*Memorandum from the
Engineering and Public
Works Department*

TO: Director of Development Services
DATE: 22 January 2025
PREPARED BY: Chris Moore, Engineering Assistant
SUBJECT: **VARIANCE PERMIT APPLICATION FILE NO. VP- 610**
OWNER: **Lana and Charles Fitt**
APPLICANT: **Lana and Charles Fitt**
LEGAL: Lot 9, Section 12, Township 20, Range 10, W6M, KDYD, Plan 9687
CIVIC: **1281– 15 Street SE**

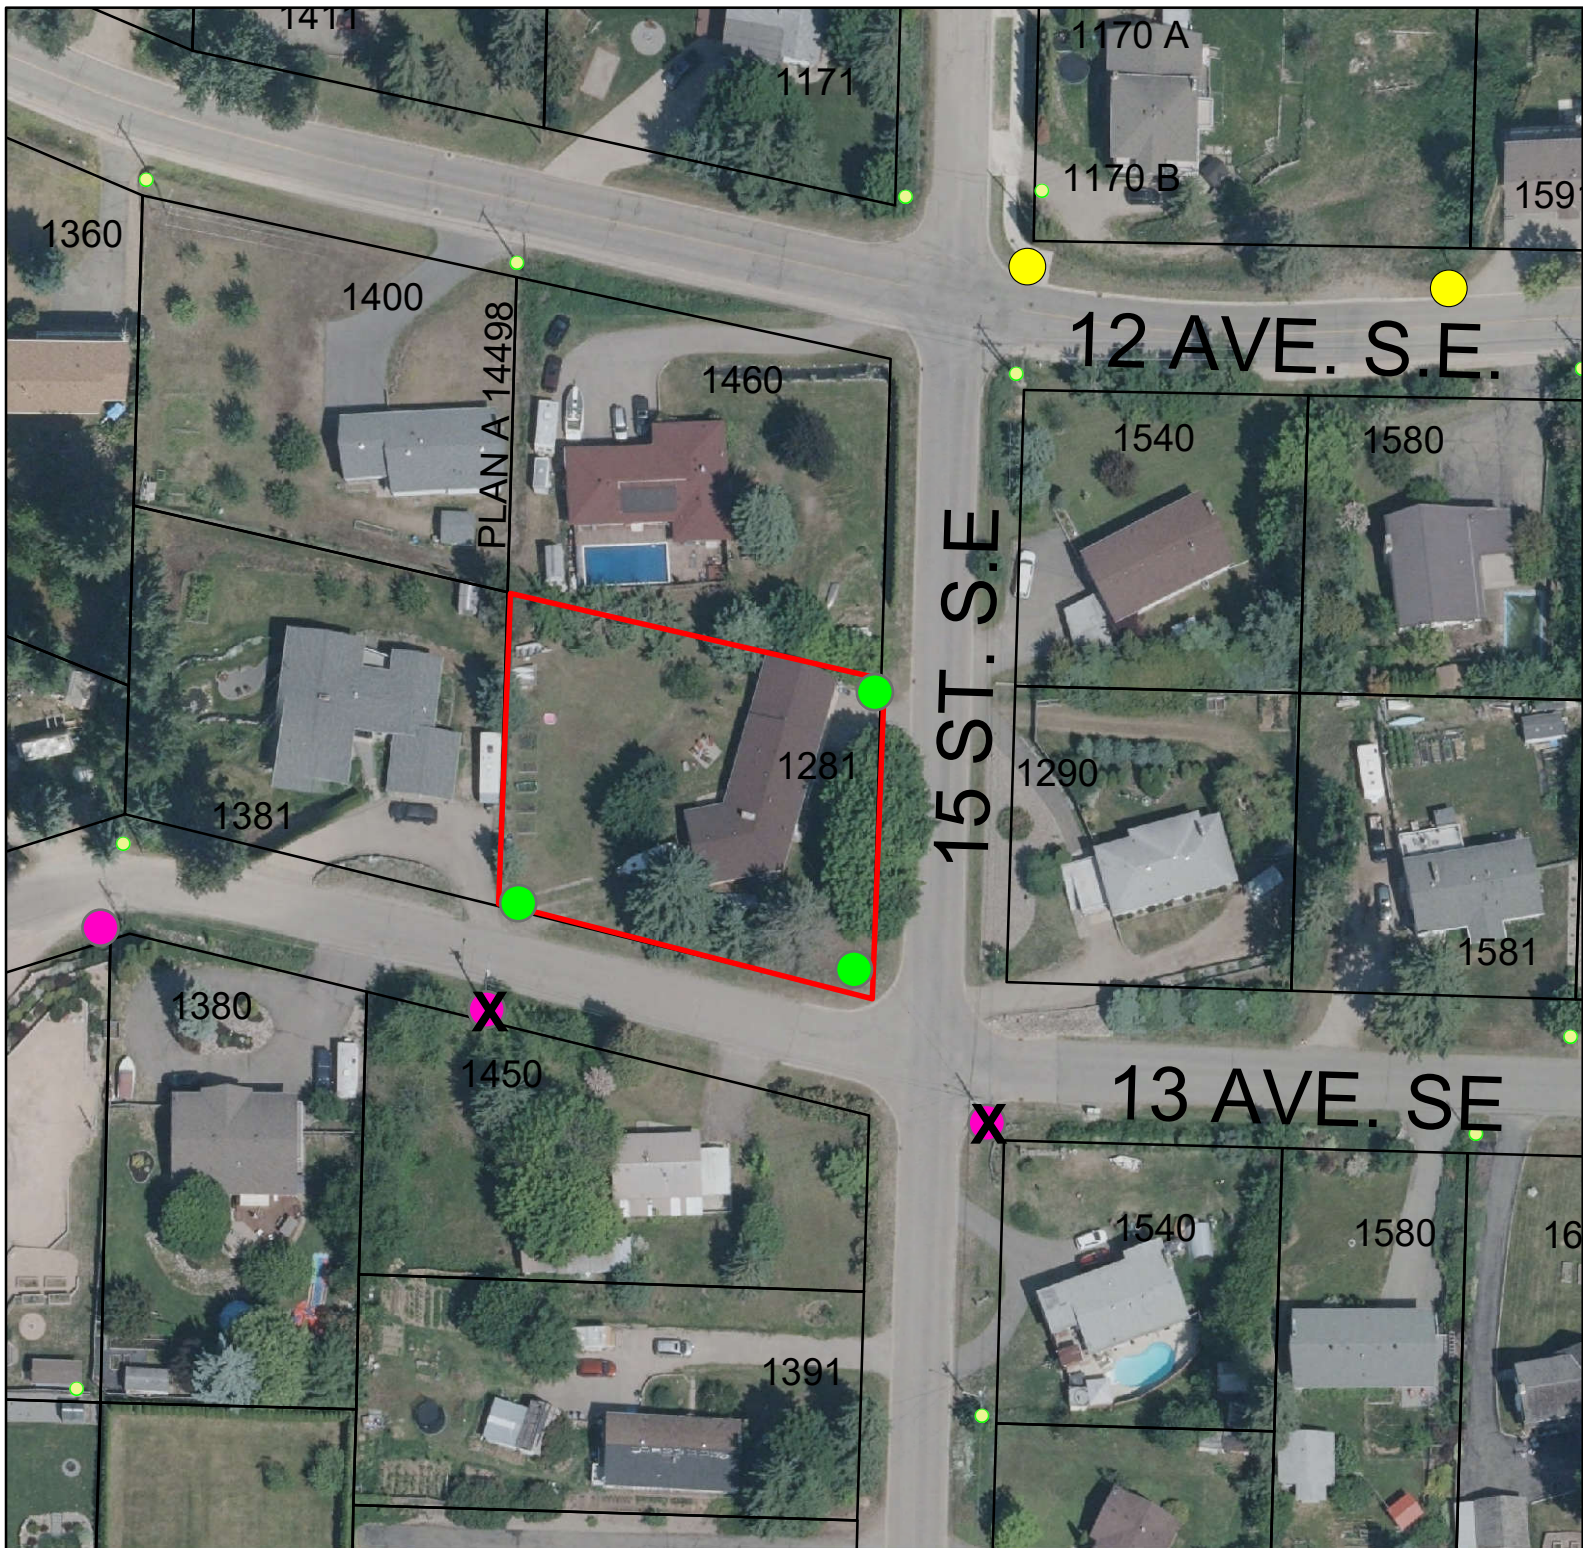
To meet the lighting standards of the SDSB, three additional street lights would be required. This assumes that the existing pole mounted lease lights are removed, as per City policy. One light would be required at the intersection of 15 Street SE and 13 Avenue SE and one light on each road approximately 40m from the first light.

In the interests of annual costs and safety, street lighting should be provided. Should Council decide to waive this requirement, the Engineering department would recommend at a minimum one new City light should be installed at the north end of the frontage on 15 Street SE as there are currently no lights between 12 Avenue SE and 13 Avenue SE. Refer to attached plan for Street light locations.

The Engineering Department recommends that request to waive the requirement to install streetlights be denied.
